Access Compliance Report

Public Rights-of-Way

(Curb Ramps)

Intersection ID: 12517	Main Street: N_SHARON_AMITY_RD	Cross Street: SHAMROCK_DR	Location: NE
ADA ID: 38B34A1CC14F	Ramp Type: Perp	Initial Pass/Fail: Fail	Overall Compliance: No
Codes/Mitigation Info/Possible Solution		Field Measurements/Component Compliance

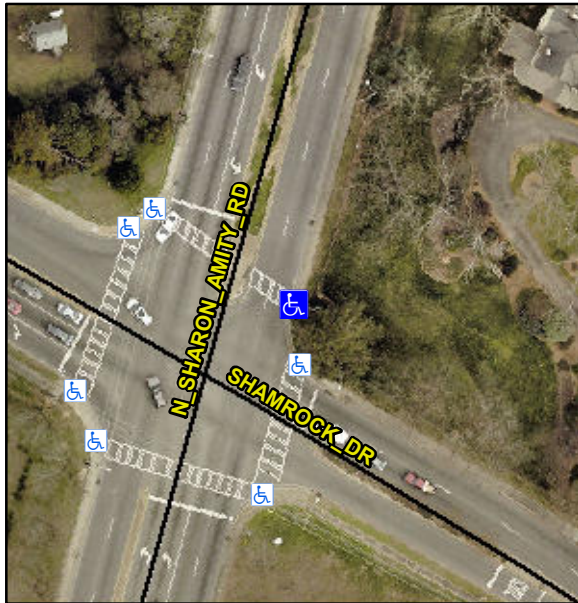
Not Found, R304.2.2, R304.5.3

Compliance	Description	Data	Compliance	Description	Data
N/A	Ramp Length (in)	59.5	No	Ramp Slope (%)	9.2
Yes	Ramp Width (in)	48.0	No	Ramp XSlope (%)	2.6
N/A	Flare Type LT	N/A	N/A	Flare Type RT	N/A
N/A	Flare Slope LT (%)	N/A	N/A	Flare Slope RT (%)	N/A
N/A	Flare Traversable LT?	N/A	N/A	Flare Traversable RT?	N/A
N/A	Landing Length (in)	N/A	N/A	DWS Provided?	N/A
N/A	Landing Width (in)	N/A	N/A	DWS Contrast?	N/A
N/A	Landing Slope (%)	N/A	N/A	DWS Length (in)	N/A
N/A	Landing X Slope (%)	N/A	N/A	DWS Full Width?	N/A
N/A	Landing Curb? (Y/N)	N/A	N/A	DWS Offset (in)	N/A
N/A	Shared Landing?	N/A			
N/A	Gutter Ponding?	N/A	N/A	Gutter Slope (%)	N/A
N/A	Gutter Lip Ht (in)	N/A	N/A	Gutter X Slope (%)	N/A
N/A	Painted X Walk1?	Yes	N/A	Painted X Walk2?	N/A
	X Walk 1 Direction	To NW		X Walk 2 Direction	N/A
N/A	X Walk 1 Width (in)	96.5	N/A	X Walk 2 Width (in)	N/A
	X Walk 1 Slope (%)	1.2		X Walk 2 Slope (%)	N/A
	X Walk 1 X Slope (%)	0.3		X Walk 2 X Slope (%)	N/A

Remove & Replace Entire Ramp.
